# Access Compliance Report

## Public Rights-of-Way

Intersection ID: 12333	Main Street: N_BREVARD_ST	Cross Street: E_7TH_ST	Location: N
ADA ID: 2D2621C7B67E	Ramp Type: Perp	Initial Pass/Fail: Fail	Overall Compliance: No
Severity Score: 13.75			
Codes/Mitigation Info/Possible Solution		Field Measurements/Component Compliance

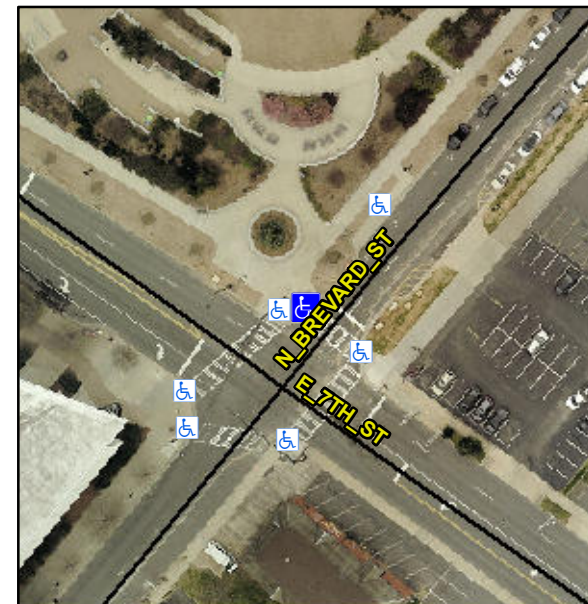
**R304.2.2**

Compliance	Description	Data	Compliance	Description	Data
N/A	Ramp Length (in)	70.0	No	Ramp Slope (%)	8.5
Yes	Ramp Width (in)	48.0	Yes	Ramp XSlope (%)	4.2
N/A	Flare Type LT	N/A	N/A	Flare Type RT	N/A
N/A	Flare Slope LT (%)	N/A	N/A	Flare Slope RT (%)	N/A
N/A	Flare Traversable LT?	N/A	N/A	Flare Traversable RT?	N/A
N/A	Landing Length (in)	N/A	N/A	DWS Provided?	N/A
N/A	Landing Width (in)	N/A	N/A	DWS Contrast?	N/A
N/A	Landing Slope (%)	N/A	N/A	DWS Length (in)	N/A
N/A	Landing X Slope (%)	N/A	N/A	DWS Full Width?	N/A
N/A	Landing Curb? (Y/N)	N/A	N/A	DWS Offset (in)	N/A
N/A	Shared Landing?	N/A			
N/A	Gutter Ponding?	N/A	N/A	Gutter Slope (%)	N/A
N/A	Gutter Lip Ht (in)	N/A	N/A	Gutter X Slope (%)	N/A
N/A	Painted X Walk1?	Yes	N/A	Painted X Walk2?	N/A
	X Walk 1 Direction	To SE		X Walk 2 Direction	N/A
N/A	X Walk 1 Width (in)	112.0	N/A	X Walk 2 Width (in)	N/A
	X Walk 1 Slope (%)	0.6		X Walk 2 Slope (%)	N/A
	X Walk 1 X Slope (%)	4.2		X Walk 2 X Slope (%)	N/A

**Remove & Replace Entire Ramp.**
